## TMPR3927 Specification Update

TMPR3927F, TMPR3927AF, TMPR3927BF, TMPR3927CF

Figure 1 Unnecessary assertion of the STOP\* signal

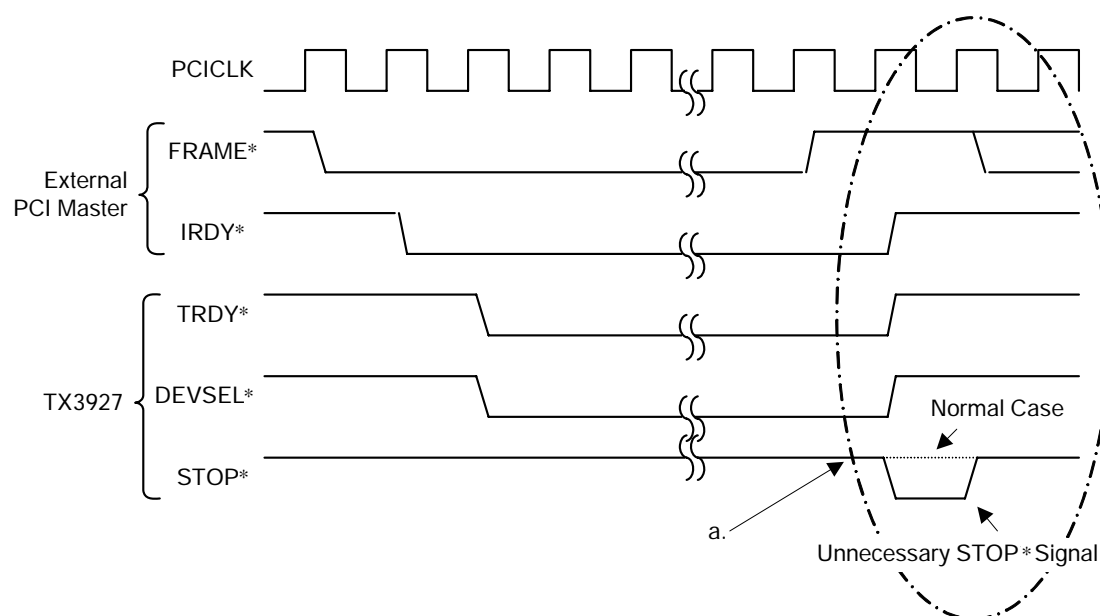
As shown in Figure 1 below, the PCI Controller in the TX3927 may, under particular conditions, assert the STOP\* signal unnecessarily exactly when the PCI bus is idle. The external PCI master may be affected by this STOP\* signal.

When the TX3927 PCI Controller is operating in Target mode and an external PCI master is bursting to the TX3927, the TX3927 PCI Controller asserts the STOP\* signal unnecessarily when the completion of the burst cycle (a in the above figure) coincides with particular conditions of the TX3927.

- 1) When all of the following conditions a) to c) are true:
  - a) Bit 3, or the OFIFO 8-Clock Rule Enable (OF8E) bit, in the Target Control (TC) register (at 0xFFFFE\_D090) of the PCI Controller is cleared.
  - b) The current burst cycle is a read.
  - c) The OFIFO becomes empty immediately before point a. in the above figure.

- 2) When all of the following conditions a) to c) are true:
  - a) Bit 4, or the IFIFO 8-Clock Rule Enable (IF8E) bit, in the Target Control (TC) register of the PCI Controller is cleared.
  - b) The current burst cycle is a write.
  - c) The IFIFO becomes full immediately before point a. in the above figure.

- 3) When all of the following conditions a) to c) are true:
  - a) Bit 11, or the PCI Snoop (PSBP) bit, in the Chip Configuration (CCFG) register at 0xFFFFE\_E000 is cleared.
  - b) The current burst cycle is a write.
  - c) The CPU core requests bus mastership at point a. in the above figure while another bus master on an internal bus is executing a bus cycle.

- 1) When the burst cycle is a read  
Set the OF8E bit in the Target Control (TC) register of the PCI Controller.

- 2) When the burst cycle is a write
  - a) Set the IF8E bit in the Target Control (TC) register of the PCI Controller.
  - b) Set the PSNP bit in the Chip Configuration (CCFG) register. In this case, however, it is prohibited to use the data cache in Write-back mode.

## SDRAMC and ROMC AC Characteristics

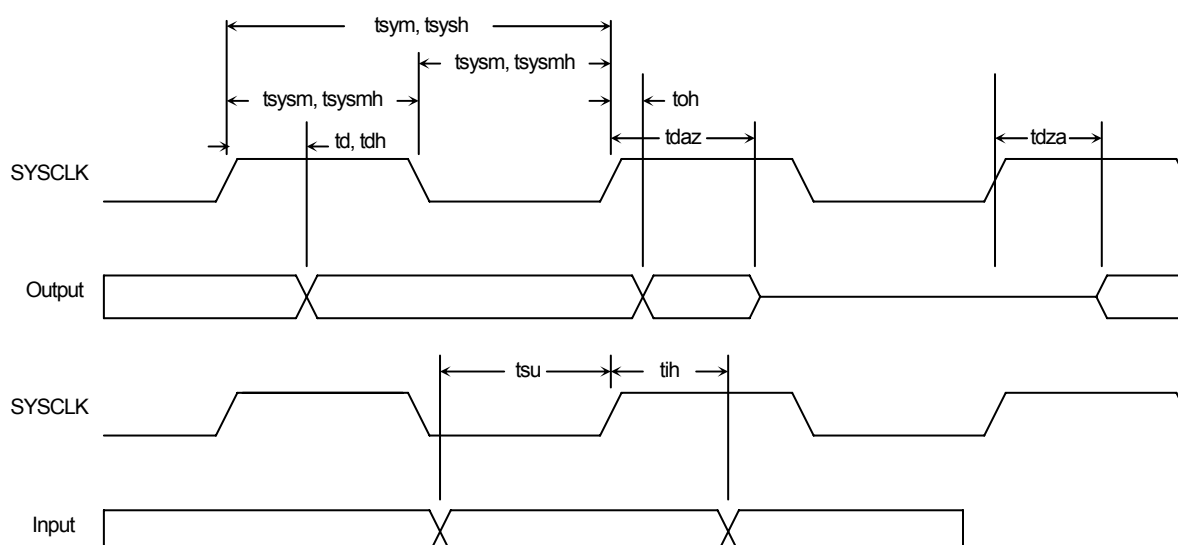
The Output Delay is defined separately for Full-Speed ( $t_d$ ) and Half-Speed ( $t_{dh}$ ) modes.

In Half-Speed mode, the specs of ADDR, ACE\*, CE\*, OE\* and BE\* differ from those of the other signals.

- 2) When more than one ROM Controller channel is used in Half-Speed mode, design a system, based on the AC specification shown on the following page.
- 3) Use the ROM Controller only in Full-Speed mode.

## Workaround Examples

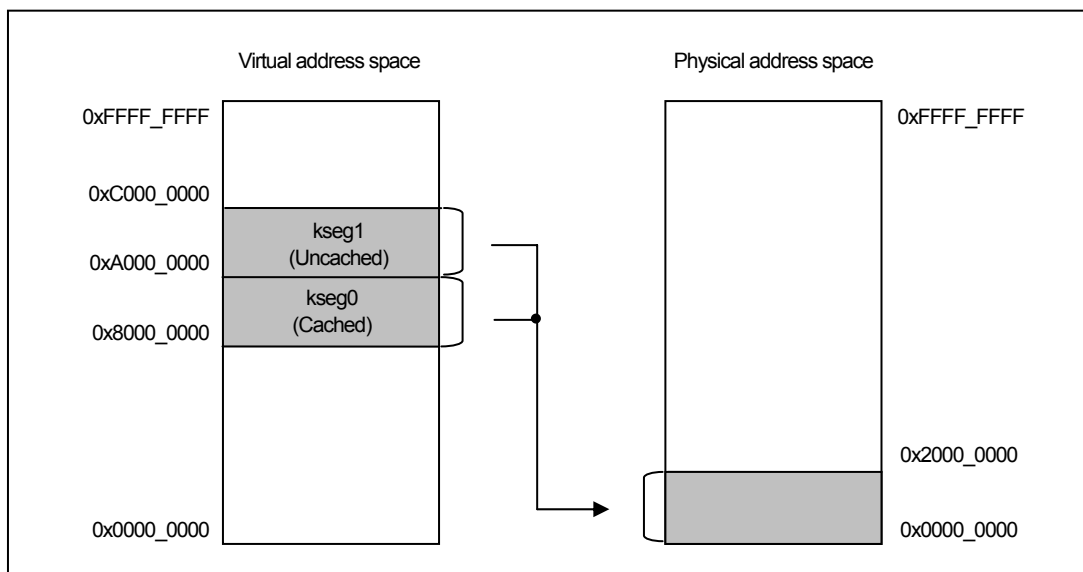
Here are examples of workaround 2 described above. In these examples, the cache is flushed without using the CACHE instruction.

0x8000\_0000–0x9FFF\_FFFF and 0xA000\_0000–0xBFFF\_FFFF in the virtual address space are mapped to the same range in the physical address space (0x0000\_0000–0x1FFF\_FFFF).

Consequently, reading data from a cached area and writing that data to an uncached area whose physical address is the same as the read address has an effect equivalent to flushing the data cache with the CACHE instruction.

### Outline and Symptom

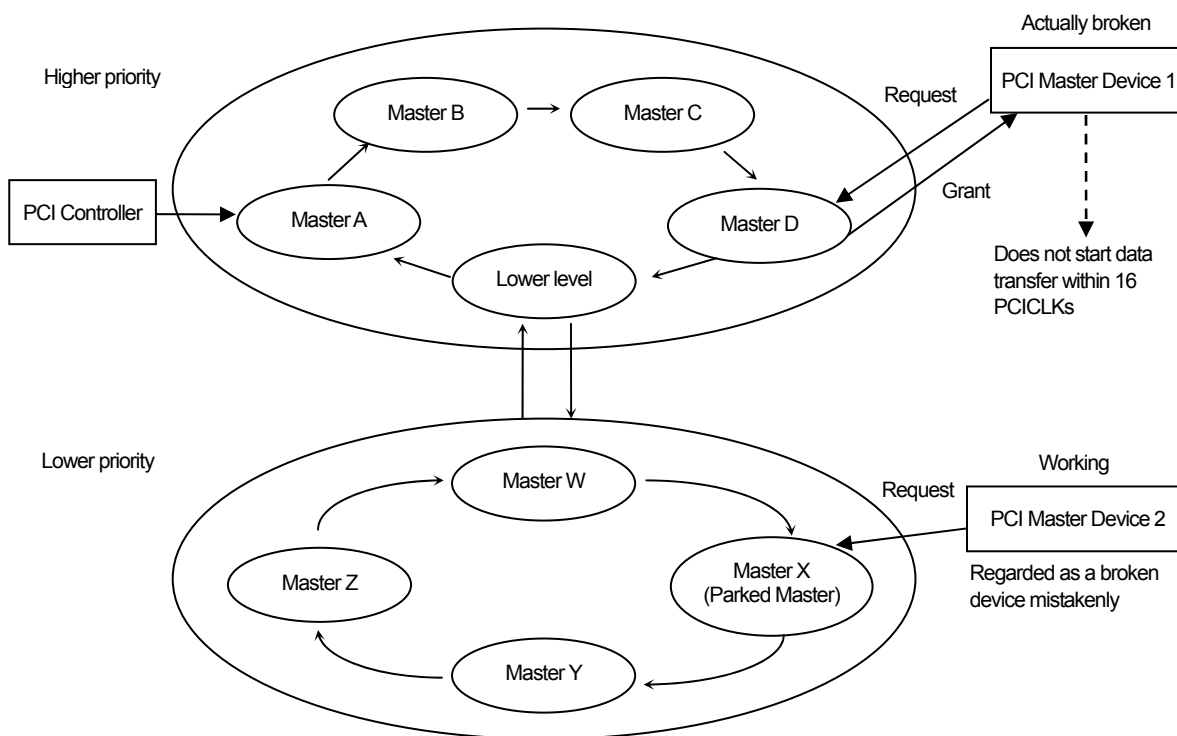
If you enable the PCI broken master checking feature, a working master device may be regarded as a broken master device and detached from the PCI bus arbiter.

When a given bus master is treated as broken, another PCI master might be treated as broken at the same time.

- (1) The Broken Master Check Enable bit is set (BMCEN=1).  
This bit is bit 0 of the PCI Bus Arbiter/Parked Master Control Register (PBAPMC). The default is 0.
- (2) There are two PCI bus arbiter groups: higher-priority group and lower-priority group (see the following figure). The assignment of PCI bus masters to the bus arbiters is specified in the Request Trace Register (REQ\_TRACE).
- (3) When a master device in the higher-priority group is detected as broken, a master device in the lower-priority group activates a PCI bus request and is given the highest priority in that group. Among the lower-priority group, master W has the highest priority upon reset. Afterwards, a master which got the PCI bus last has the highest priority. (A master with the highest priority is called a parked master.)
